From: Michelle Peed <MPeed@gilesengr.com>
Sent: Thursday, August 18, 2022 4:07 PM
To: Grittner, Paul V - DNR
Cc: Kevin Bugel
Subject: Re: Initial questions - 02-41-589921 333 N. Water Street
Attachments: IMG_7404.jpg; Figure 6 (Engineered Barrier Map) rev 8-17-2022.pdf; Figure X1 (Remedial Excavation).pdf

From: Grittner, Paul V - DNR <Paul.Grittner@wisconsin.gov>
Sent: Wednesday, August 10, 2022 3:02 PM
To: Michelle Peed <MPeed@gilesengr.com>
Subject: Initial questions - 02-41-589921 333 N. Water Street

Re: 333 N. Water Street – 02-41-589921

FIGURE 6
ENGINEERED BARRIER MAP
333 N. WATER STREET
MILWAUKEE, WISCONSIN

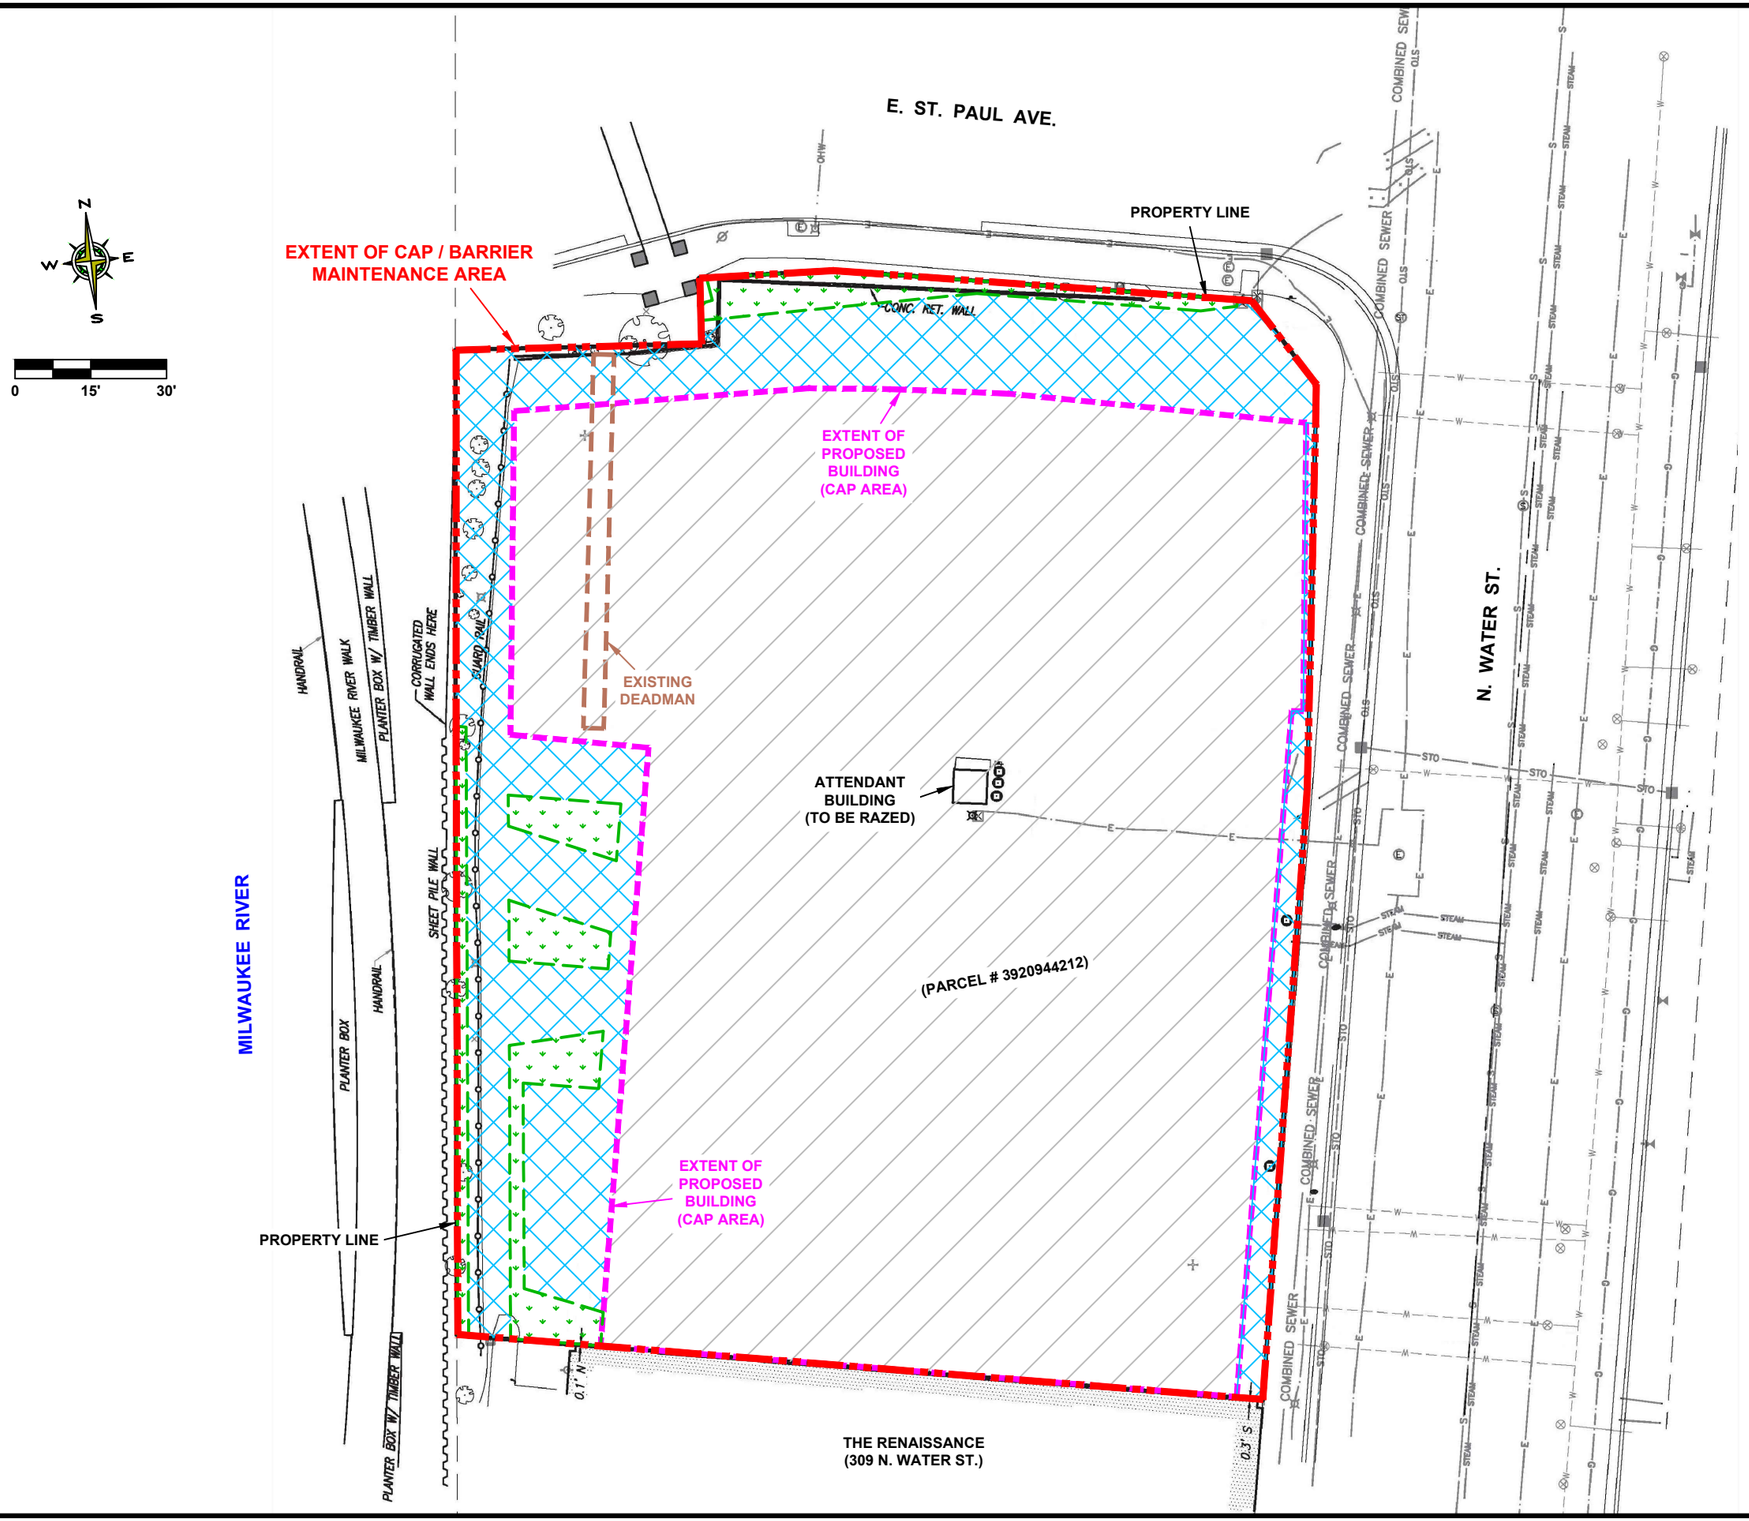
- A description of barriers that will be in place in non-paved areas of the site. Specifically, what is the composition of the barriers and how thick will the material be. Provide a figure that clearly identifies where these barriers will be located. Paved areas will be 8 inches of concrete underlain by 6 inches of gravel. Landscaped beds will be at at least 12 inches deep under the plants with indicator fabric denoting impacted soil below. Soil below trees will be excavated to a depth of at least 24 inches.

FIGURE X1
REMEDIAL EXCAVATION
333 N. WATER STREET
MILWAUKEE, WISCONSIN

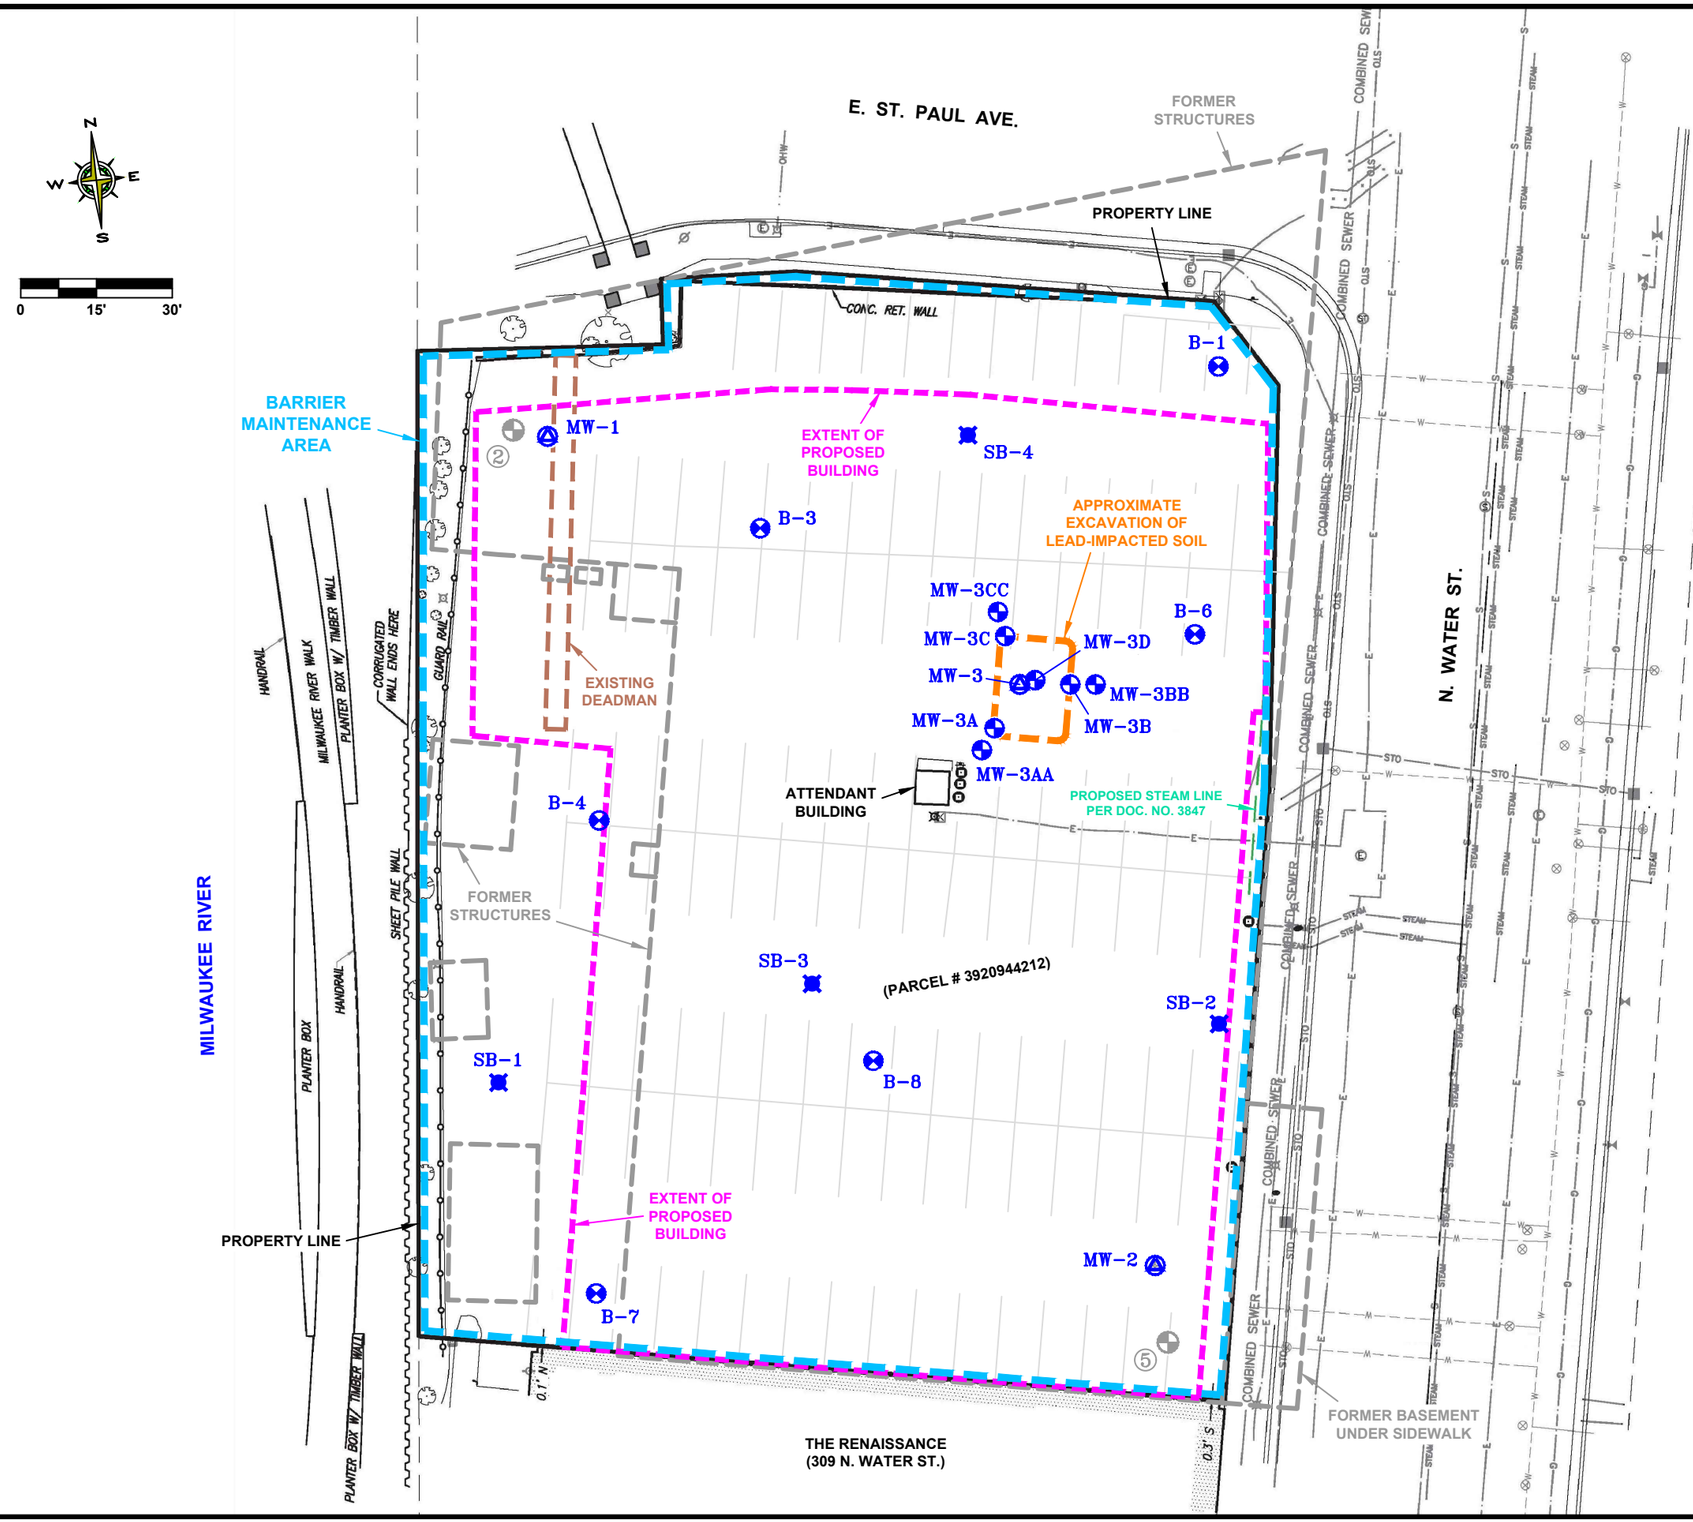
- A figure with the proposed remedial excavation limits Please see attached figure. We will add the area around SB-1 and revise as necessary at MW-3 when we get additional TCE results next week. We will send an updated map and discuss with you at that time.
